গণপ্রজাতন্ত্রী বাংলাদেশ সরকার
শ্রম ও কর্মসংস্থান মন্ত্রণালয়
কলকারখানা ও প্রতিষ্ঠান পরিদর্শন অধিদপ্তর

ক্যাপ পর্যবেক্ষণের তথ্য

কারখানার নাম	আর টেক্স কাশন লিঃ		
ঠিকানা	146, Satarkul Road, North Badda		
কারখানার কোড	DHK476		
কালার কোড

মূল্যায়নের ধরণ: বৈদ্যুতিক মূল্যায়ন	পর্যবেক্ষণের তারিখ: ০৩-০৪-২০২৩
১. পর্যবেক্ষণ

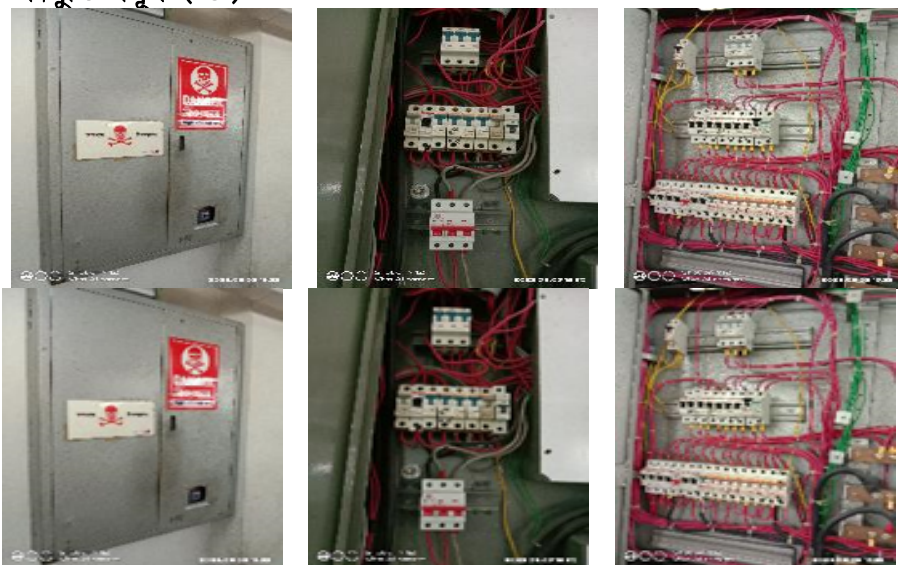
পরিদর্শন পর্যবেক্ষণ	<p>□ No instruction for first aid to electrical shock □ Cable ends not properly soldered or crimped □ Connection without lug □ Undressed messy wire inside □ Body & door not earthed □ No clear identification mark on distribution board □ MDB/SDB/SB or MCB installed on the wooden board</p>
ক্যাপ আইটেম ক্যাটাগরি

কার্যক্রম	<p>□ Provide instructions for first aid from exposure to electrical shock □ Ensure well-dressed cabling with lugs</p>
সুপারিশের তথ্যসূত্র	
কারখানার কার্যক্রম	
অগ্রাধিকার	প্রযোজ্য নয়
চূড়ান্ত সময়সীমা	-
সংশোধিত সময়সীমা	০১-০১-১৯৭০
অগ্রগতির অবস্থা	শুরু হয়নি
মন্তব্য	<p>19/10/2020: 1. Instructions for first aid from exposure to electrical shock were not provided. 2. Cables were not well dressed. Cable looping was present in all the boards. 04/01/2021: 1. Instructions for first aid from exposure to electrical shock were not provided. 2. Cables were not well dressed. Cable looping was present in all the boards. 07-09-2021: Instructions for first aid from exposure to electrical shock were not provided. Cables were not well dressed. Cable looping was present in all the boards. 03-08-2022 visit observation: 1. Instructions for first aid from exposure to electrical shock were not found. 2. Cables were not well dressed. 3. Cable looping were found. 03.04.2023: 1. Instructions for first aid from exposure to electrical shock were not found. 2. Cables were not well dressed. 3. Cable looping were found.</p>
